***Healey Falls GS - New G1
Notification of Conditional Approval of Connection Proposal
CAA ID Number: 2005-EX260a***

ASSESSMENT SUMMARY

Ontario Power Generation

Figure 1 - Power flows at Havelock TS for January 1, 2005 through January 1, 2008

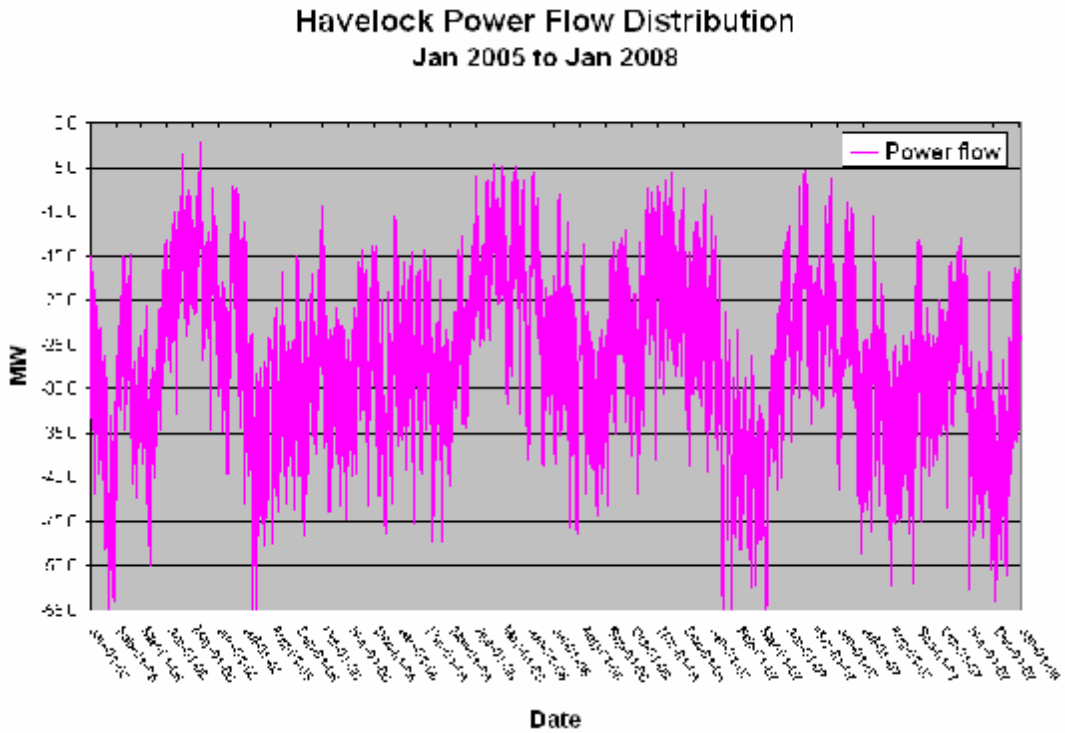
Historical power flows at Havelock were examined for the three year period from January 1, 2005 through January 1, 2008. Figure 1 shows the power flow at Havelock T1 and T2 over that period of time.

Figure 2: Power flow distribution at Havelock T.S.

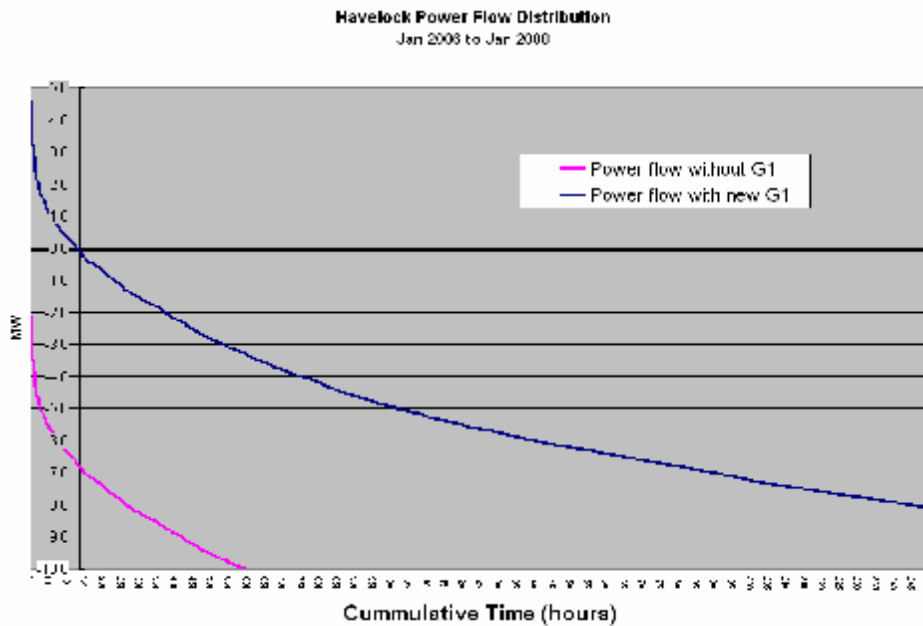
Assuming an increase of 6.7 MW in generation as discussed in section 2.1, net injections to the IESO-controlled grid could occur for up to 135 hours per year. The net injection into the IESO-controlled grid is not likely to exceed 4.6 MW. See figure 2 for details.

Figure 4 - Proposed G1 Arrangement at Healey Falls GS

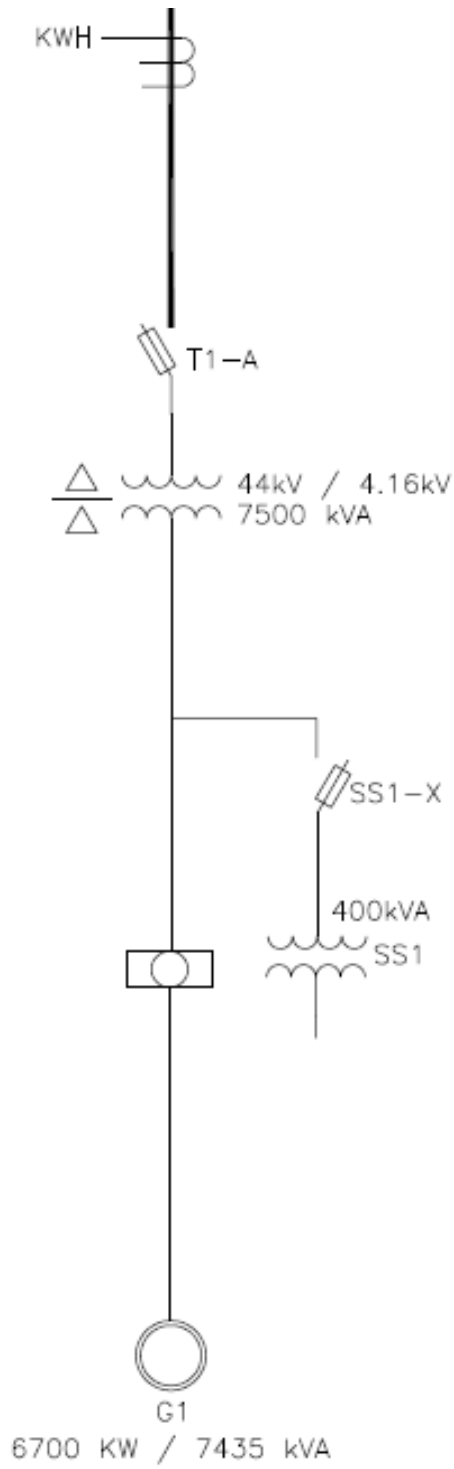
The single line diagram shows the presence of a synchronizing breaker, transformer and disconnect switch. See figure 4 for the proposed arrangement.

Transformer T1 will meet the following specifications:

- § 7.5 MVA ONAF
- § 44/4.16 kV
- § delta/delta configuration
- § Z=7.0%

The step-up transformer T1 is rated slightly higher than the capacity of the new generator G1.
